ADDENDUM NO.	1	DATED	8/17/2015	ADDENDUM NO.		DATED	
ADDENDUM NO		DATED		ADDENDUM NO.		DATED

Number	Description
1	Revised Table of Contents; Add NTB Nos. 5786 & 5787; SP 907-622-7, replaces SP 907-622-6; Revised BidItems; Revised or Added Plan Sht. Nos. 2, 4-11, 13-16, 22-25, 27-31, 33, 34, 38, 46-49, 85, 86, 88, 93-95, 212, 213, 220-223, 249-251, 256-259, 262, 263, 319, 320, 331-333, 2001, 2031, 6315, 6316, & 6324; Amendment EBS Download Required.

PROJECT: STP-0056-01(075) / 104101301 - Rankin

Construction necessary to Add 2 Lanes to SR 25 from SR 475 to Grants Ferry Road, known as Federal Aid Project No. STP-0056-01(075) / 104101301 in Rankin County.

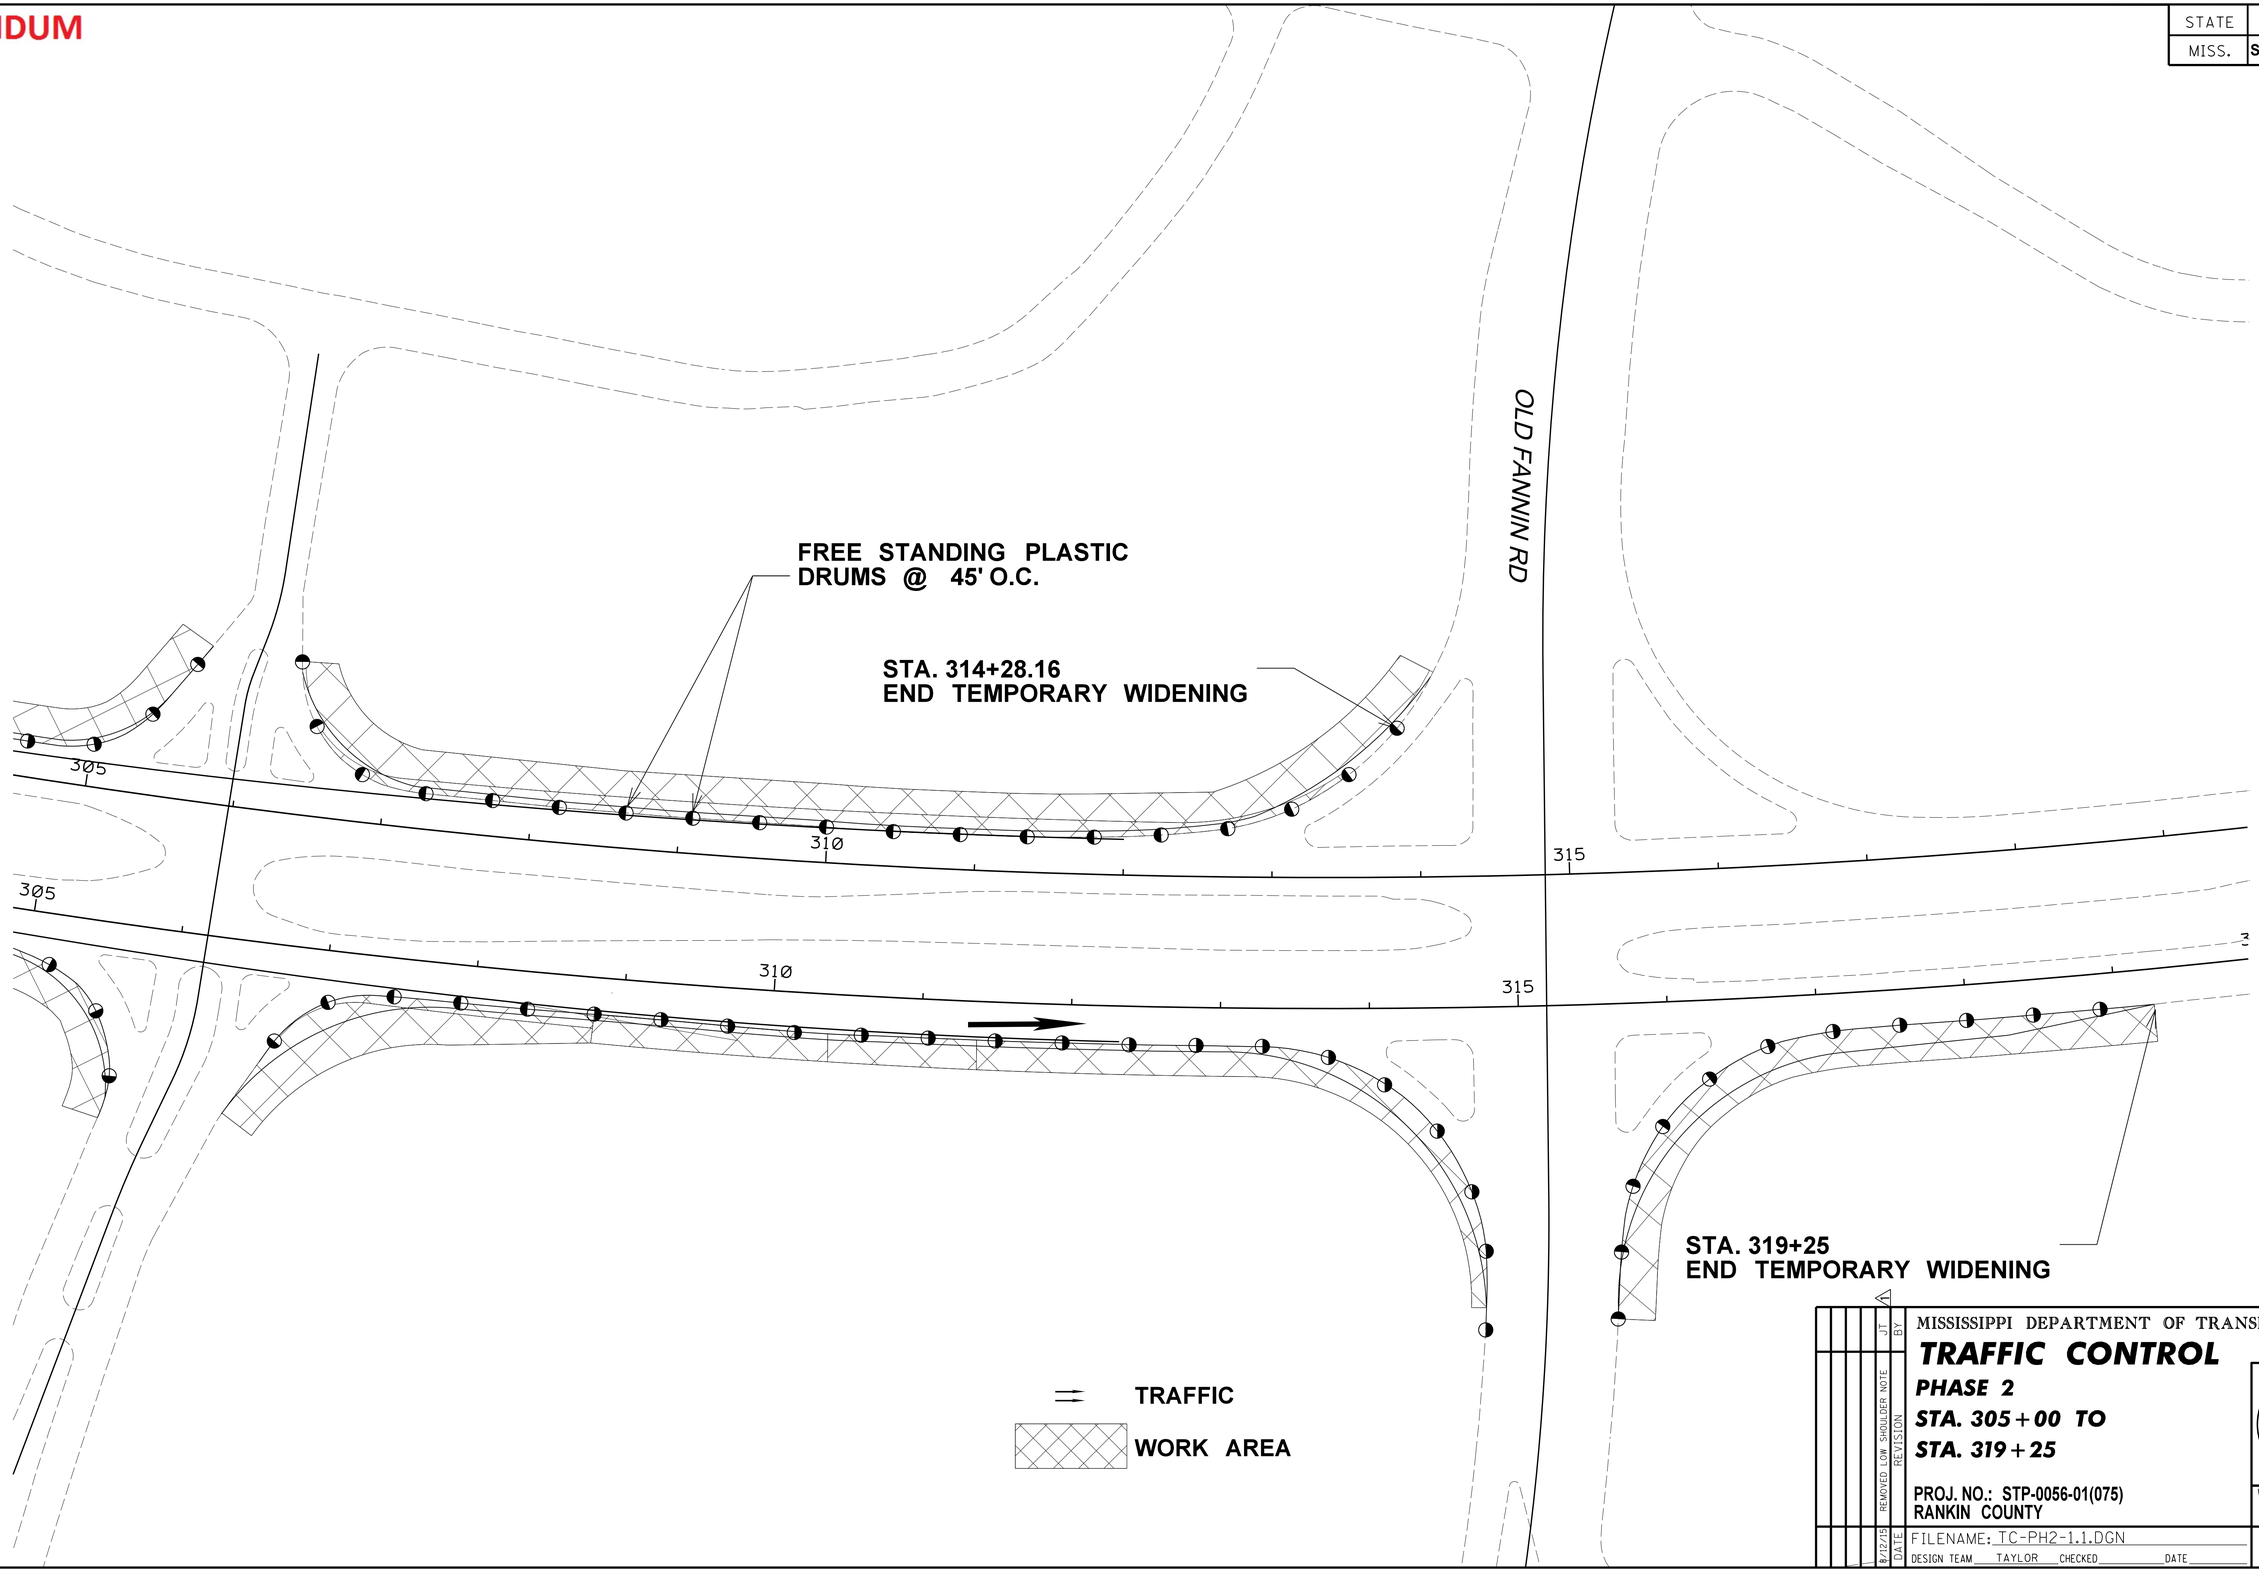
8/12/15	REMOVED LOW SHOULDER NOTE	JT	
DATE	REVISION	BY

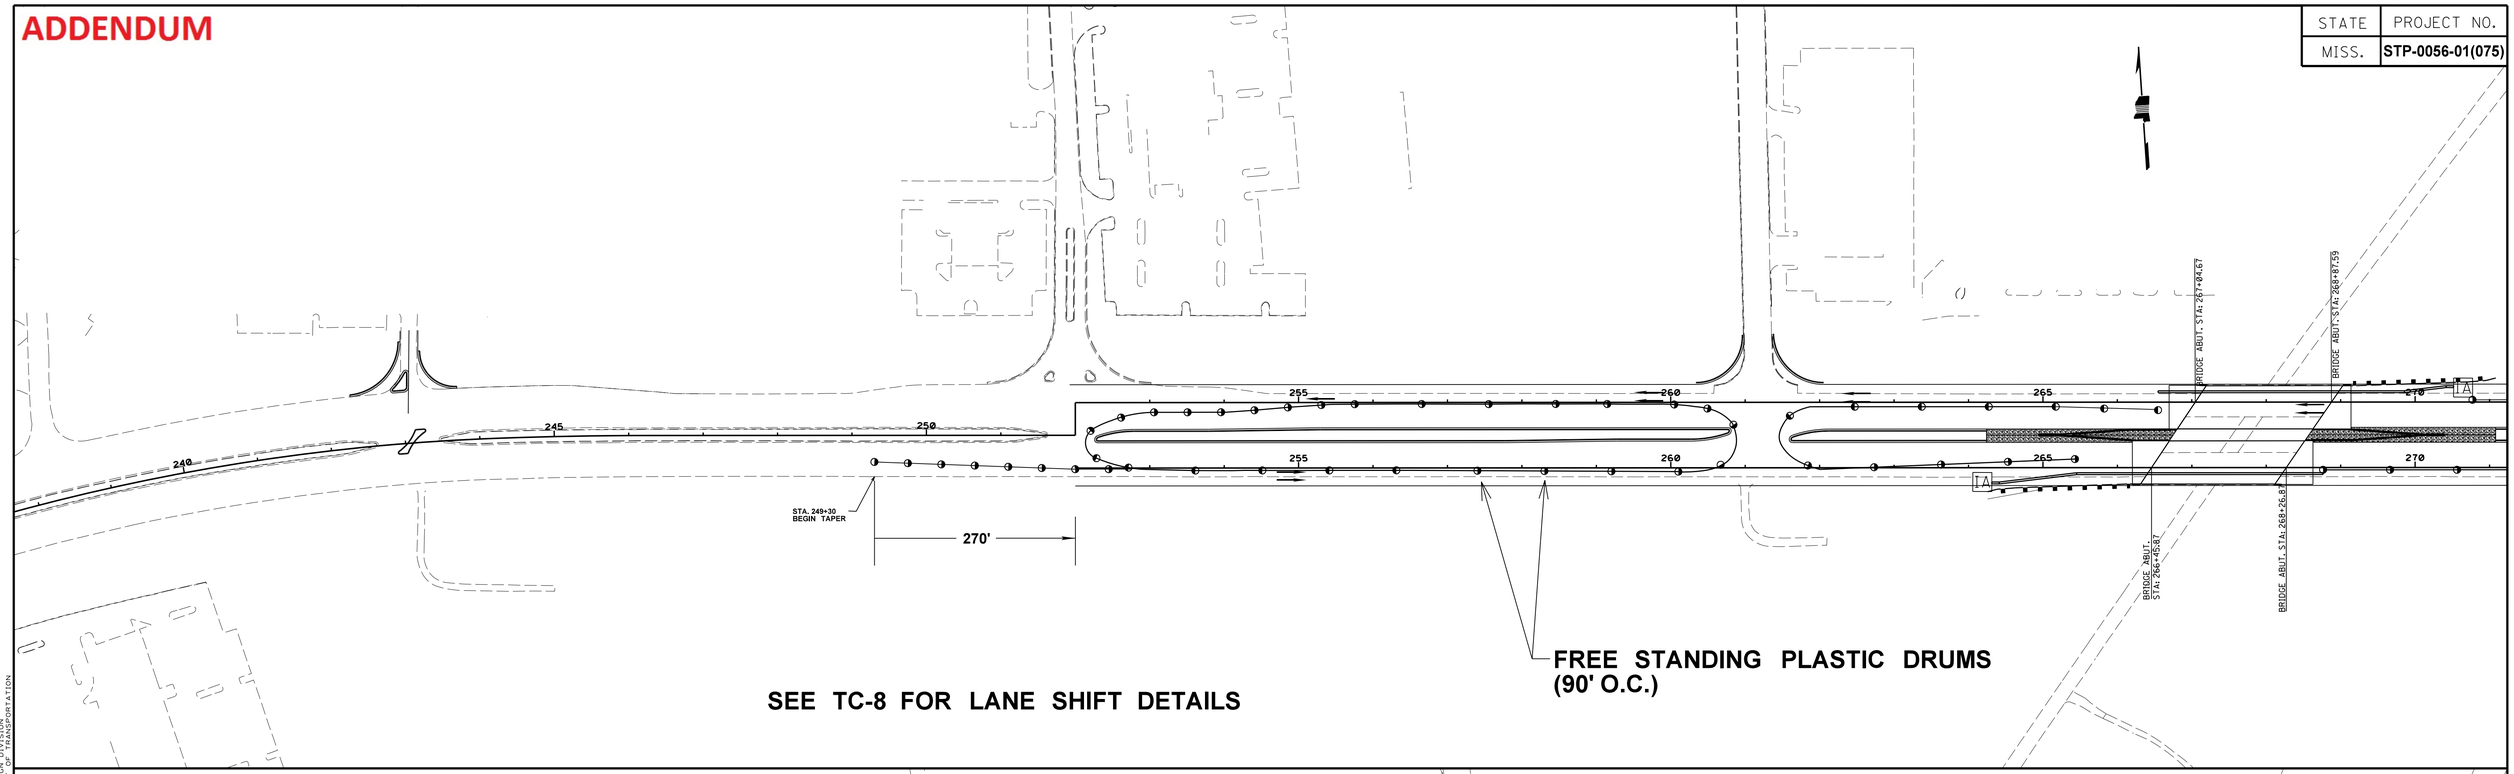
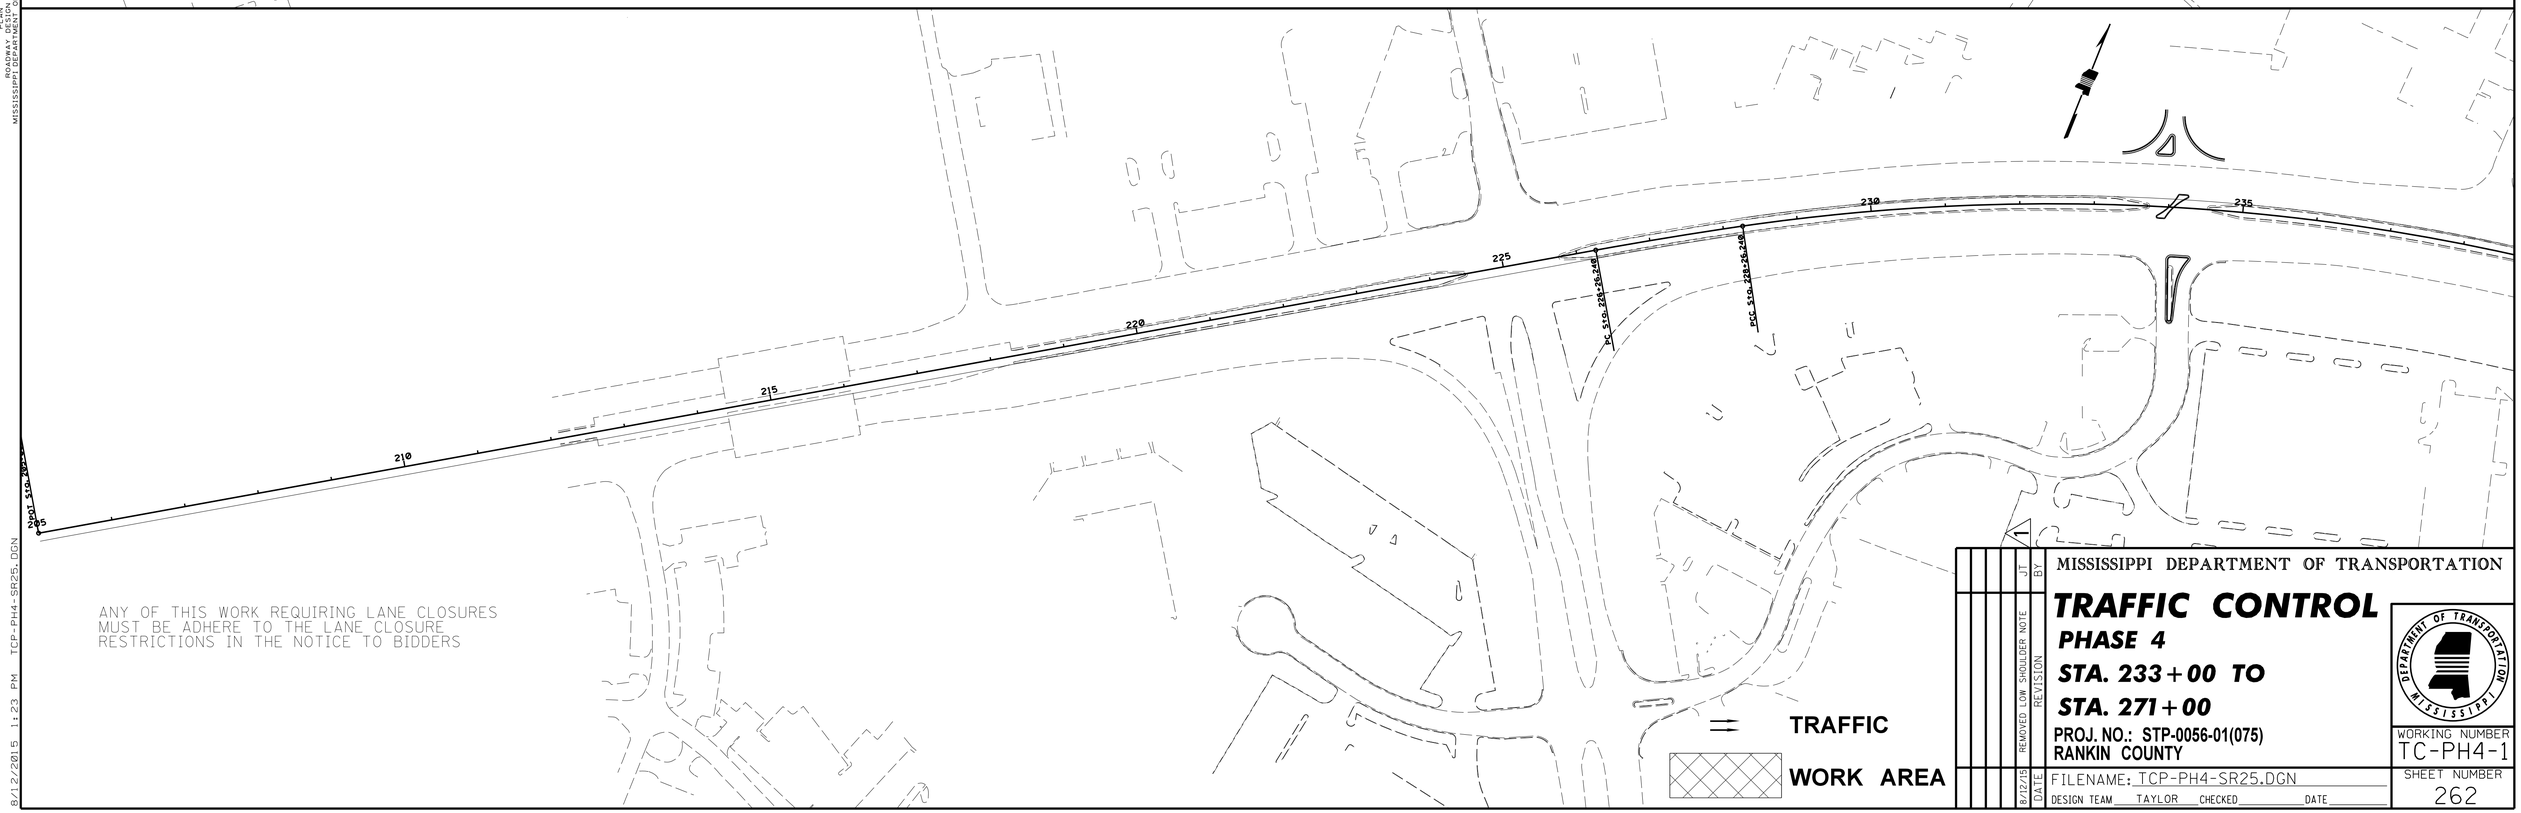
DATE	REVISION	BY
8/12/15	REMOVED LOW SHOULDER NOTE	JT
